Job No: P26264
 Name: HOPKINSON
 Address: 10K5
 Tel: _____
 Sheet: _____ of: _____

P26264
 HOPKINSON
 30r5

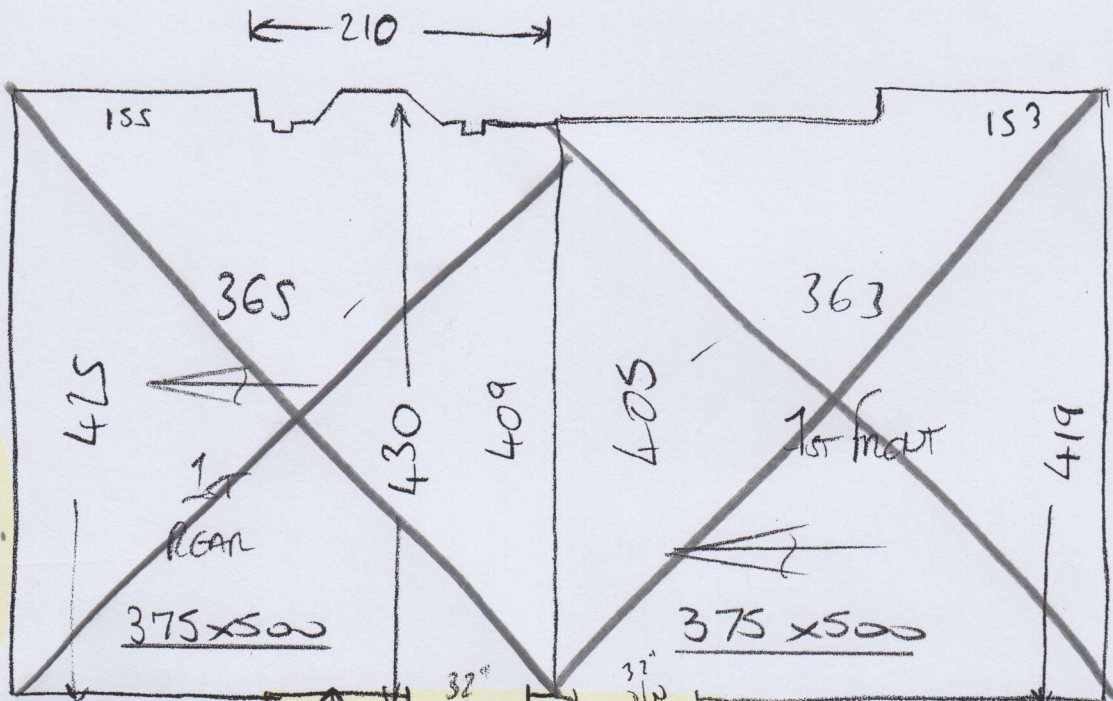
MIKE
 THIS HAS BEEN CHECK MEASURED & IS VERY TIGHT (RE-RANDED TO FIT).

PLEASE ROLL OUT, MEASURE & CUT 560 PIECE FOR TOP ROOM & STAIRS

CHECK MEASURE THE REMAINING 1010 & CUT THE 720 & 290 FROM IT.

CONTACT JACK IF IT IS ANY SHORTER.

THIS ROOM WILL NOW REQUIRE A SEAM TO A SMALL RECESS

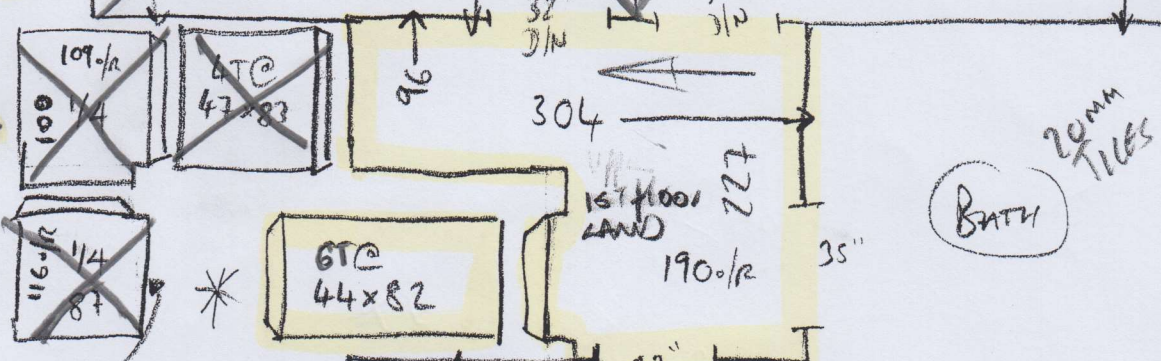
THESE STAIRS
 HAVE CHANGED.
 SEE 20r5

~~ABOVE THIS
 POINT TO BE
 CHANGED~~

~~New Left STAIRS~~

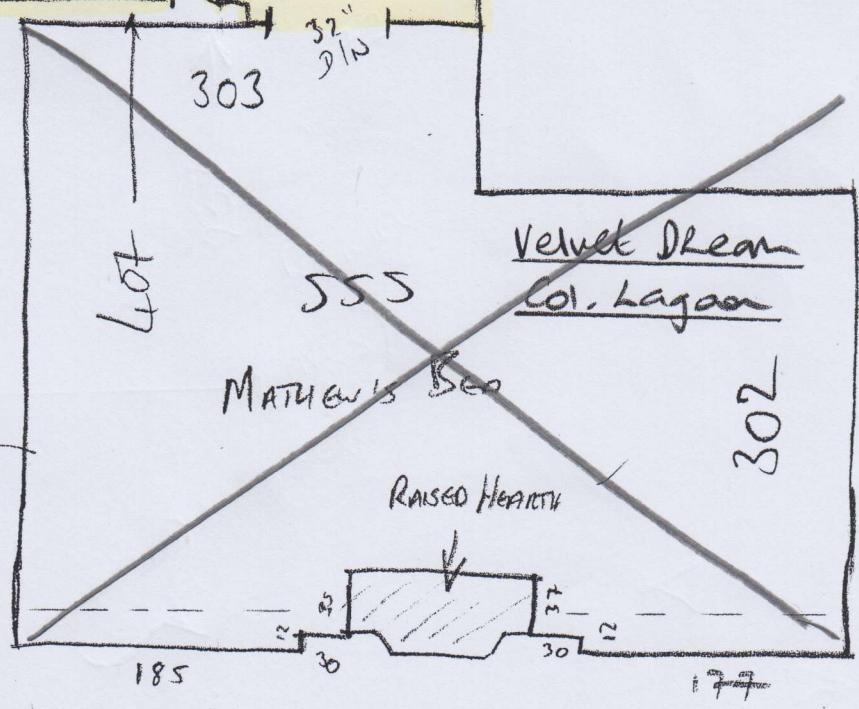
RAISED HEARTH

~~These stairs not built
 yet (C. 10/1/2005)~~

P26264
 HOPKINSON
 40FS

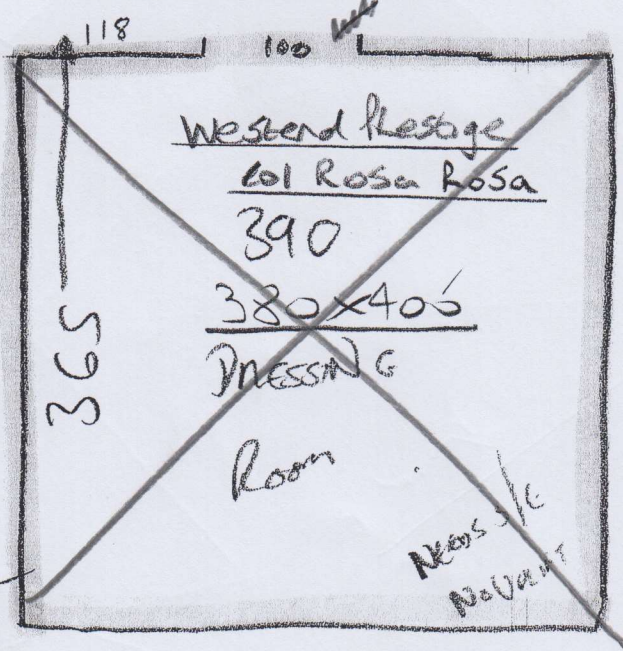
TILES ARE 10mm HIGHER THAN CARPET + U/LAY FIT 9mm SHIM + T/E

Fix Refers
29/4
